**AUDITOR CERTIFICATION
REPORT & STATEMENT OF
REASONS: PROSERPINE FIRE
STATION, 102 MAIN STREET,
PROSERPINE, QLD
QUEENSLAND FIRE AND EMERGENCY
SERVICES**

19 FEBRUARY 2020
719052
VERSION 1

**Auditor certification report and statement of reasons: Detailed site investigation (DSI)
for Proserpine Fire Station, 102 Main Street, Proserpine, Queensland**

Figure 1: Site location Plan (reproduced from AECOM 2019b)

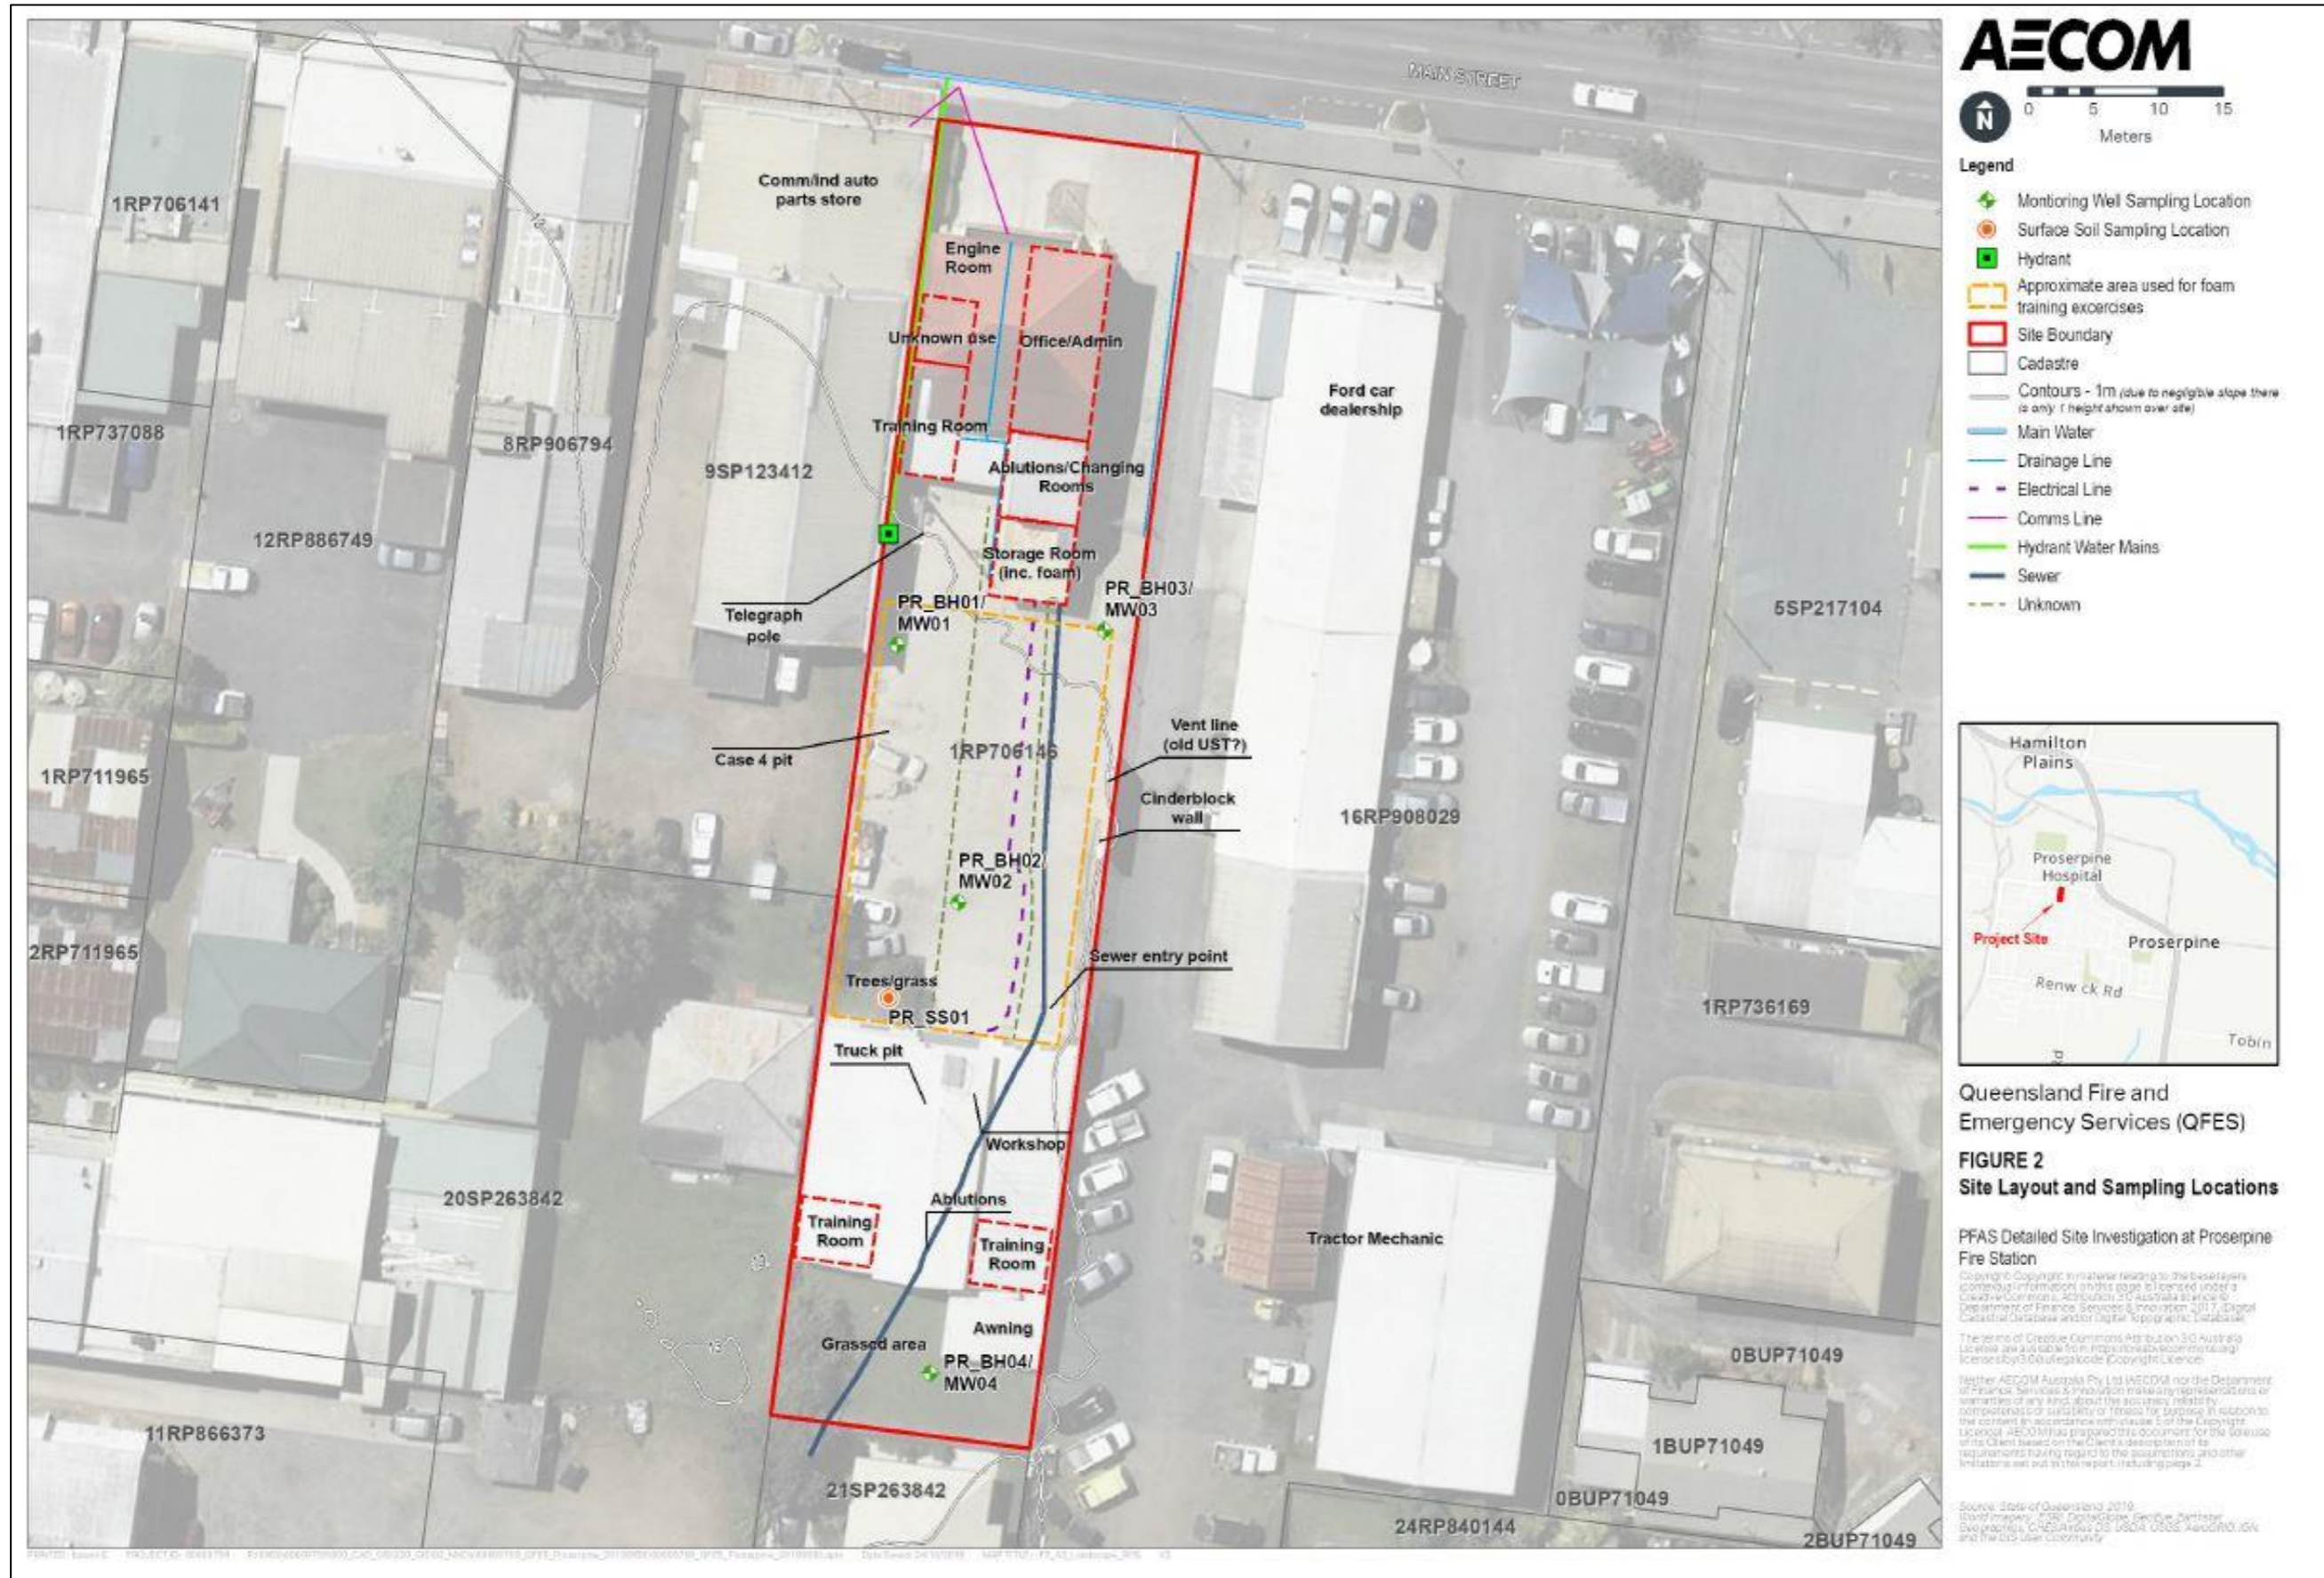
3.	Figures	Figure 1	<ul style="list-style-type: none"> • Bore RN162365 does not appear to be shown on Figure 1. • RN162343 (bottom) and RN12200225 (centre, top), are missing registered bore symbols, (although it is noted these locations may be difficult to who, in the vicinity of other nearby wells, at this resolution, please check and amend as necessary. • Please check symbol to the left of RN131800 (right side of diagram) – this symbol appears to be missing a label. • Given accompanying Table 4 presents data for those registered bores within 500 m of the site, it may be beneficial to add a “500 m site radius” to the Figure.
